# UNITED STATES PATENT AND TRADEMARK OFFICE

APPLICATION NO.	FILING DATE	FIRST NAMED INVENTOR	ATTORNEY DOCKET NO.	CONFIRMATION NO.
10/811,975	03/30/2004	Kazumasa Makino	119306	2989
25944	7590 09/20/2005		EXAMINER	
OLIFF & BERRIDGE, PLC P.O. BOX 19928		VERBITSKY, GAIL KAPLAN		
	RIA, VA 22320	•	ART UNIT	PAPER NUMBER
			2859

#### **DETAILED ACTION**

FIG. 2

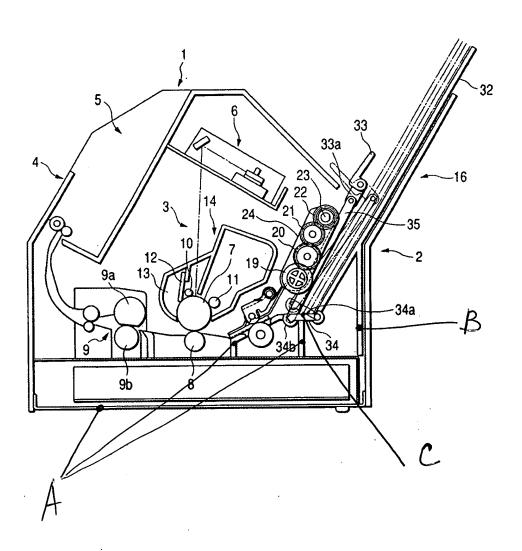
Kojima discloses in Figs. 2, 4, 9 an image forming unit comprising an image forming device (portion) 3 that forms an image on a recording medium (paper) delivered from a storage/ feeding/ paper tray 32, inherently, attached to the image forming unit, a feeding roller (first guide member) 24, a paper supply roller 19 that makes contact of the recording medium and feeds it into a contact with the image forming device 3, with a device frame A supporting the image forming device and located at its bottom (as

opposed to locating in a cover), a first storage frame B attached (connected) to the device frame A by means of a first attaching (connecting) means C (34). (The numerals A-C have been added by the Examiner, see attachment # 1 to the Office Action). The device, inherently, has a cover portion.

all acument #2 (09/14/05)

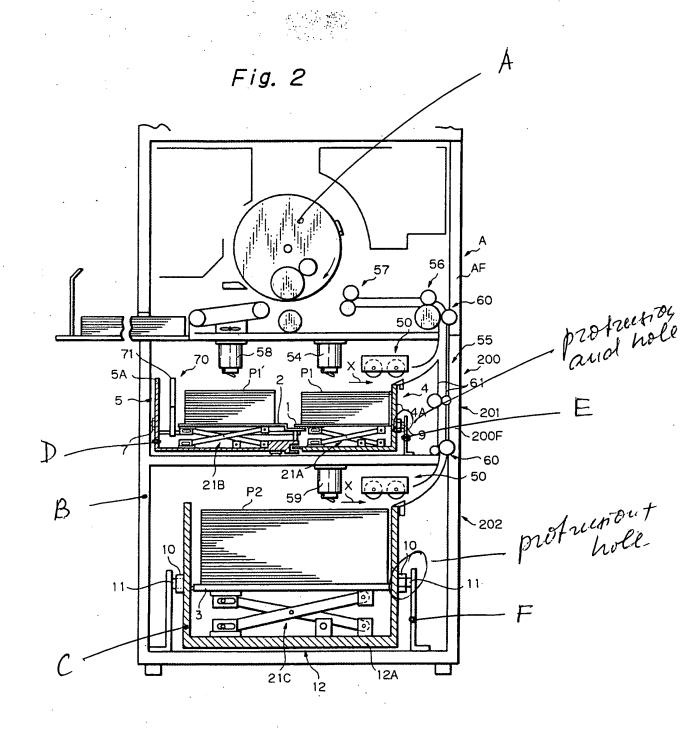
Sato discloses in Fig. 2 an image forming unit comprising an image forming device (portion) A that forms an image on a recording medium (paper) delivered from a storage/ feeding/ paper trays P1-P3 of different capacity, first, second (and third) feeding members 60, a device frame B supporting the image forming device and located at its bottom (as opposed to locating in a cover), (a plurality) a first storage frame C and a second storage frame D are attached (connected) to the device frame B by means of a first attaching (connecting) means 11 and a second attaching 9connecting) means 9, the attaching means located on protrusion means E, F of the device frame B. As shown in Fig. 2, the protrusion means E, F are inserted into the storage frames C and D. This would imply, that the storage frames C and D have openings/ holes for such an attachment. The device has a cover whose length is substantially equal to the length of the frame. There is a paper supply roller 50, 57 to supply the recording medium in contact with the image forming device. (The numerals A-F have been added by the Examiner, see attachment # 2 to the Office Action).
